City of
Richmond

Report to Development Permit Panel

File: DP 15-694729

Re: Application by Jacken Investments Inc. for a Development Permit at 10591,
10611 and 10631 Gilbert Road

DRAWING TITLE
 ELEVATIONS

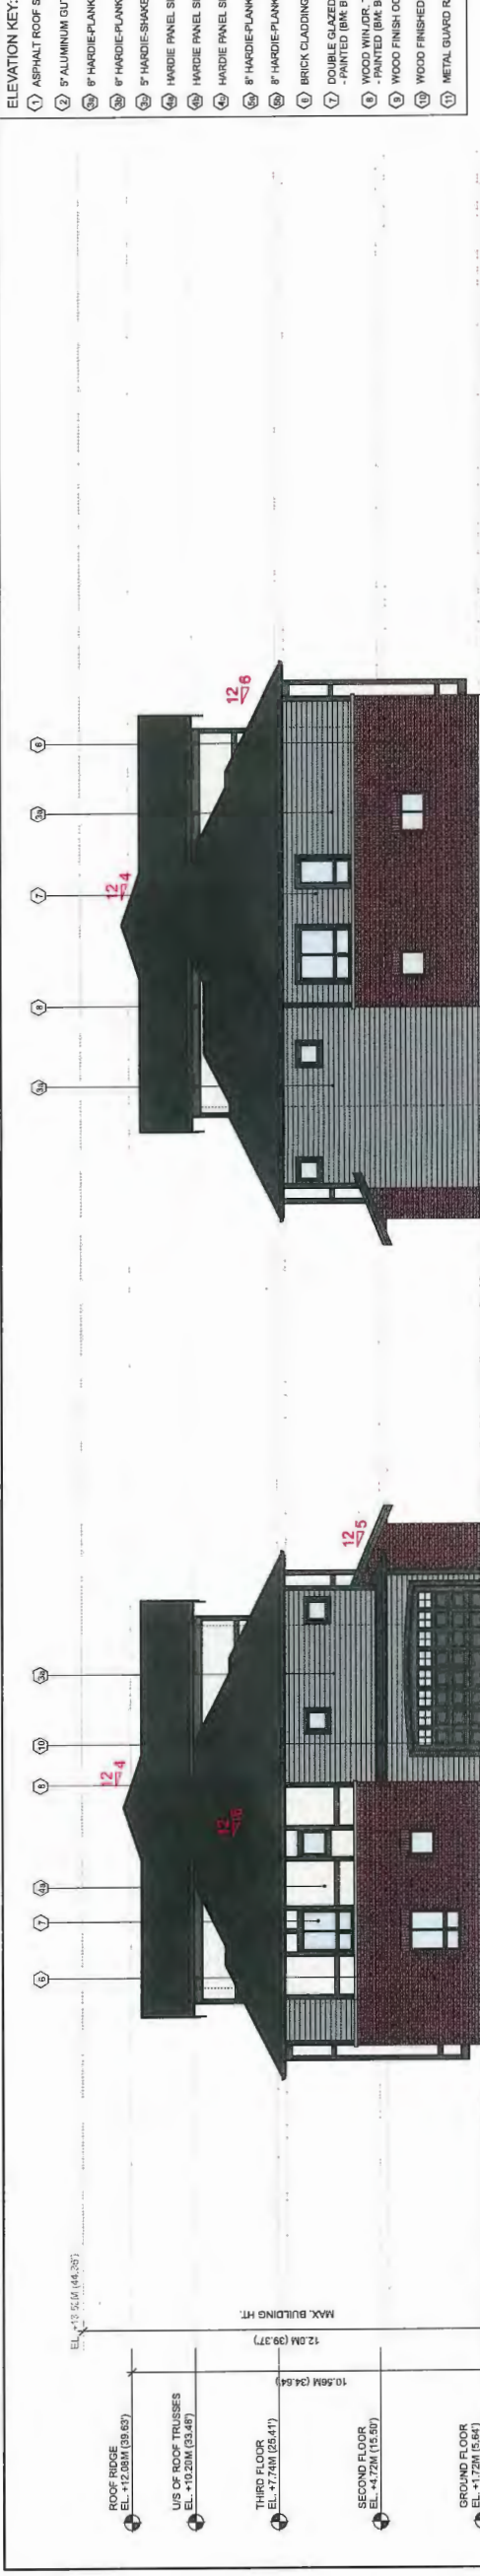
- applicant needs to clarify whether there is a garage door in the west elevation (internal drive aisle) of the B unit in Buildings 1 and 6 as shown in the architectural drawings submitted by the applicant to the Panel;

Garage door for B/Bb units of Bldg 1 & 6 provided at the north/south main drive aisle. Sliding doors with access to the garbage & recycling are proposed at the west elevations of these units.

SECOND FLOOR PLAN
SCALE: 1/8" = 1'-0"

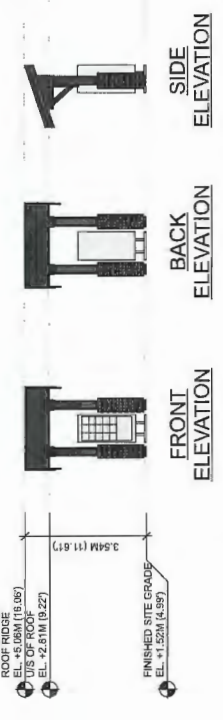
- consider an 800 mm door width for powder rooms in townhouse units;

800mm width pocket doors provided.
